Metropolitan Historic Zoning Commission
Sunnyside in Sevier Park
3000 Granny White Pike
Nashville, Tennessee 37204
Telephone: (615) 862-7970
Fax: (615) 862-7974

STAFF RECOMMENDATION
122 Windsor Drive
September 21, 2016

Application: New construction—addition
District: Belle Meade Links Triangle Neighborhood Conservation Zoning Overlay
Council District: 23
Map and Parcel Number: 13001017300
Applicant: Jeff Steele
Project Lead: Melissa Baldock, melissa.baldock@nashville.gov

Figure 1. 122 Windsor Drive

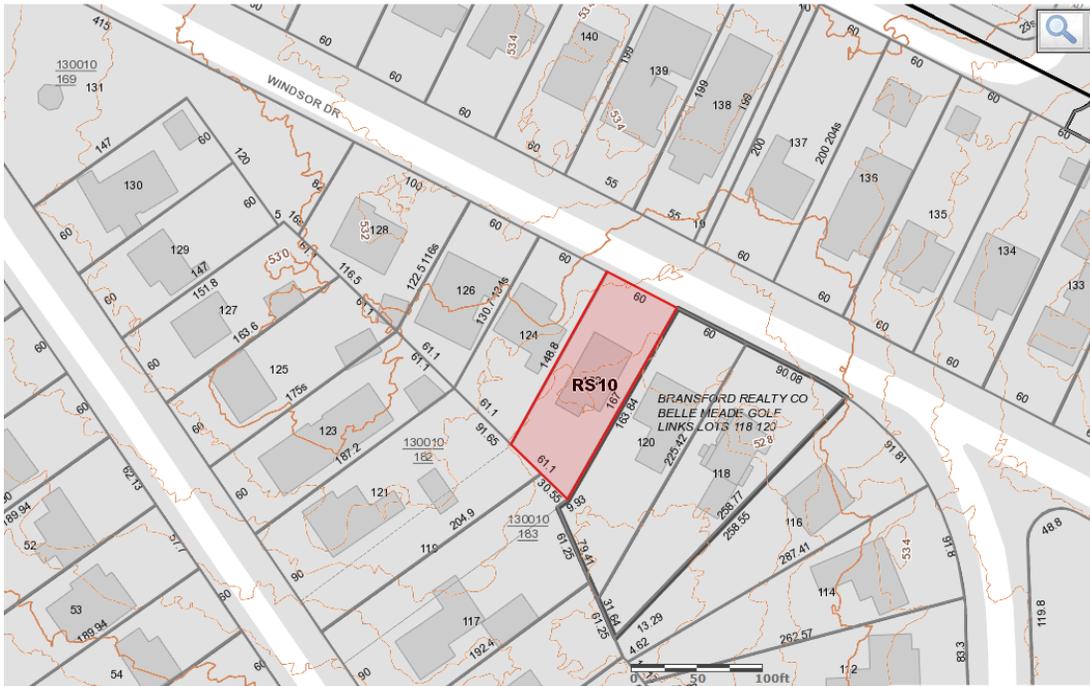
Background: 122 Windsor Drive is a c. 1934 painted brick Tudor Revival style house that contributes to the historic character of the Belle Meade Links Triangle Neighborhood Conservation Zoning Overlay (Figure 1).

ARCHITECTURAL SITE PLAN

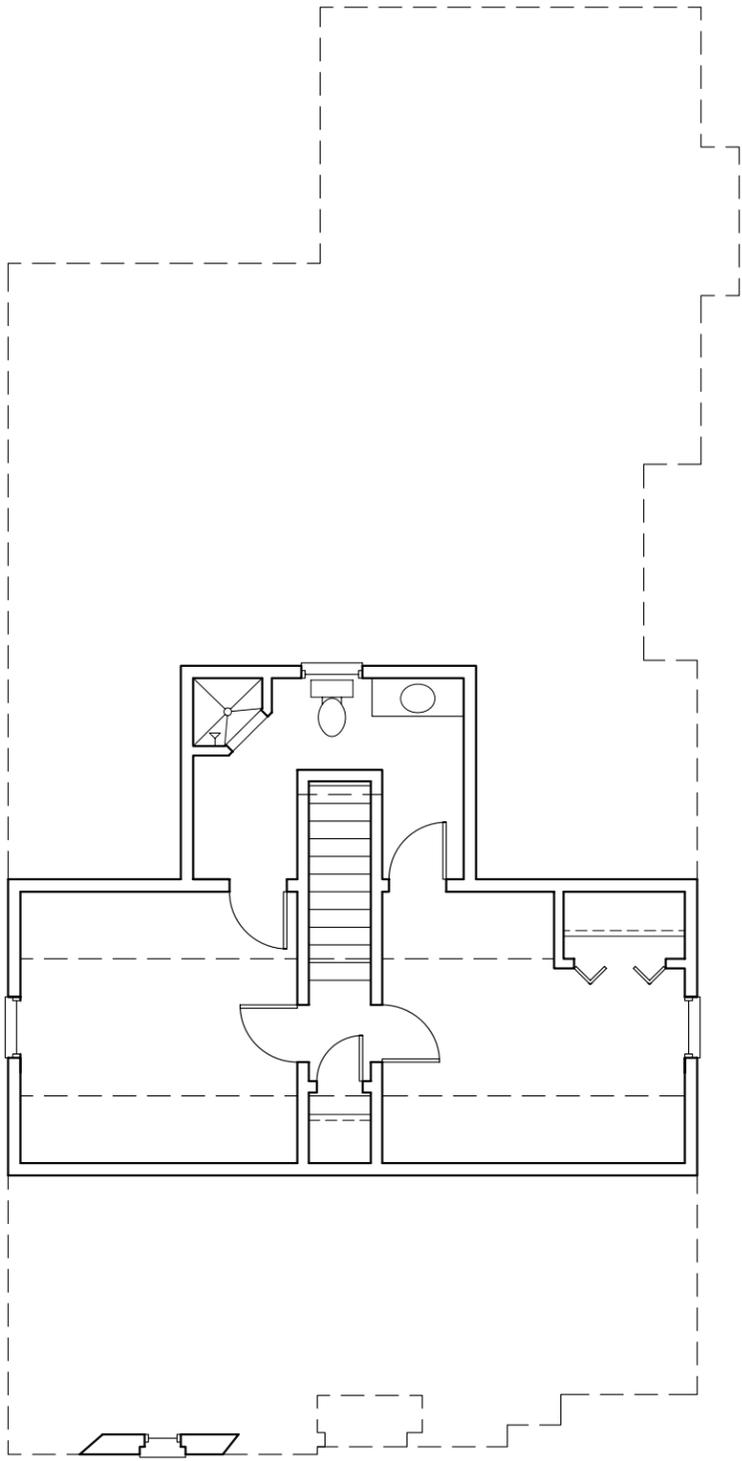
Setback & Rhythm of Spacing: The proposed addition meets all base zoning setbacks. The portion of the addition that is wider than the historic house will not affect the block’s rhythm of spacing because it is setback more than eighty feet (80’) from the front property line. Staff finds that the proposed addition’s setback and rhythm of spacing meets Sections II.B.1.c. and II.B.2. of the design guidelines.

Appurtenances & Utilities: No changes to the site's appurtenances were indicated on the drawings. The location of the HVAC and other utilities was also not noted. Staff asks that the HVAC be located on the rear façade, or on a side façade beyond the midpoint of the house.

1. Staff approve the final details, dimensions and materials of windows and doors prior to purchase and installation;
2. Staff approve all roof colors, dimensions and textures; and
3. The HVAC be located behind the house or on either side, beyond the mid-point of the house.

REMODELED EAST ELEVATION

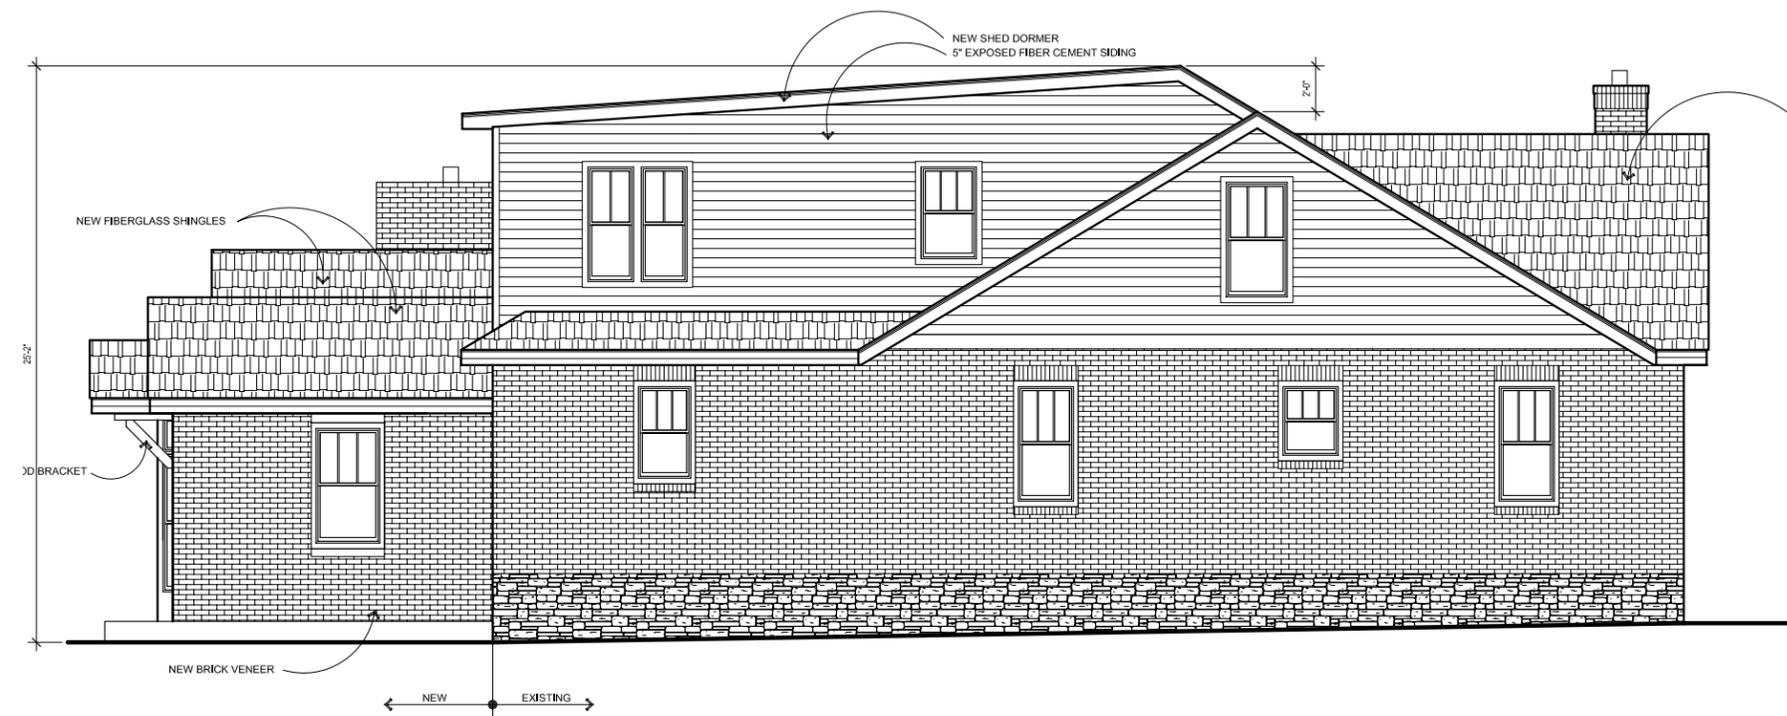
Partial Demolition: The project includes installing a new window opening on the east elevation, towards the back, on a part of the house that is an addition. Because this section of the house is an addition, staff finds that the partial demolition of the wall for a new window opening is appropriate. Staff therefore finds that the project meets Section III.B.2. for appropriate demolition and does not meet Section III.B.1. for inappropriate demolition.

Proportion and Rhythm of Openings: As described under "Partial Demolition," a new window opening will be created on the right elevation on the existing addition. The windows on the proposed addition are all generally twice as tall as they are wide, thereby meeting the historic proportions of openings. There are no large expanses of wall space without a window or door opening. Staff finds that the project's proportion and rhythm of openings meet Sections II.B.1.g. and II.B.2. of the design guidelines.
